Cork County Council

RE: Part 8 Planning Report for public carpark, Doneraile

Fig 2. Google Street view of Protected Entrance, subject is to the right of same (Wall with mural)

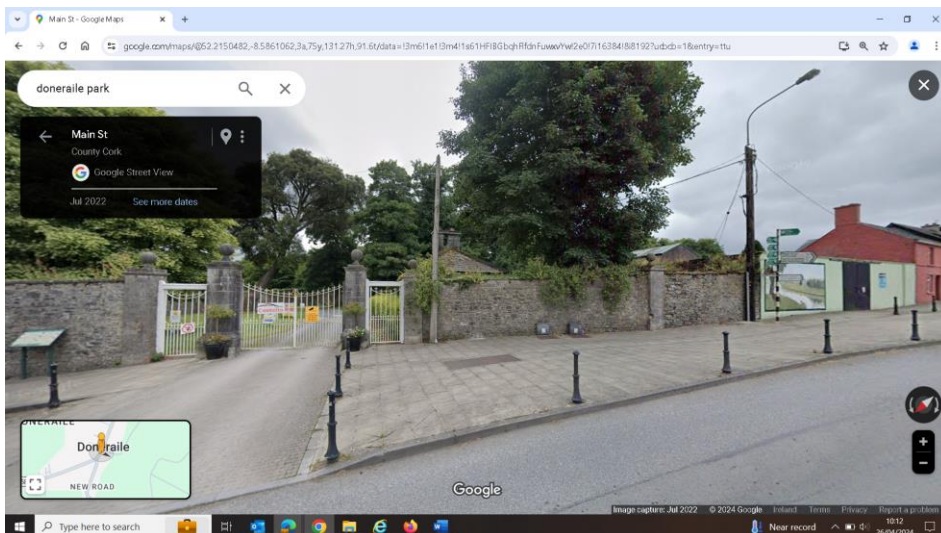
It is considered that the proposed development is well located at the edge of the village core, but is at a sensitive location within the ACA and adjacent to RPS (Doneraile Court Gated Entrance).

I also note that the site boundary wall to the road includes a mural which I believe is of sentimental important locally- I have no issues with its removal from conservation standpoint as it is not historic, but it is something you may want to discuss with local groups as you make plans.

Fig 3. Junction of MainStreet and New Street (Google Streetview, July 2022)

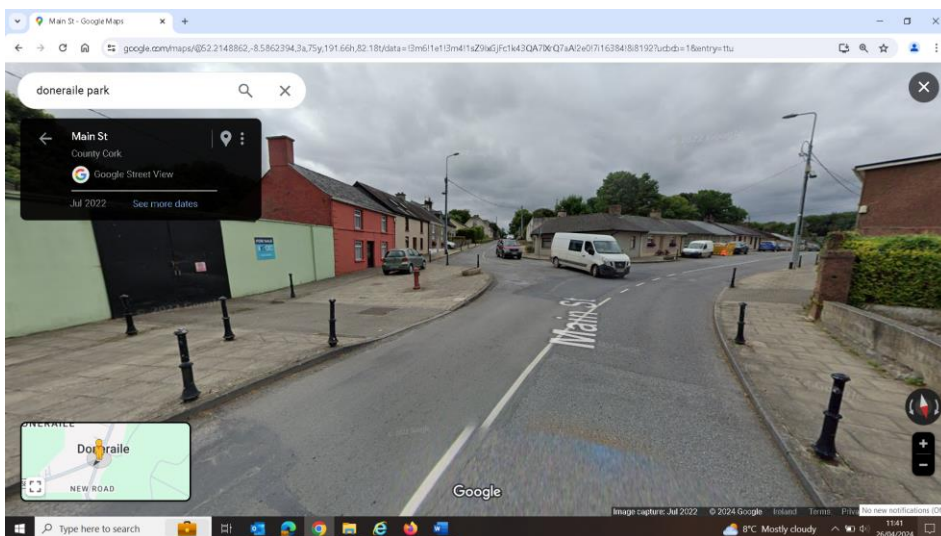
Furthermore, the proximity to the junction of MainStreet and New Street necessitates an assessment by a Roads Engineer and/or the Traffic & Transport Engineers to ensure safe entry and egress arrangements and safe crossing of pedestrians/ cyclists and careful /sensitive treatment of surface and controls/street furniture given it location within an ACA.
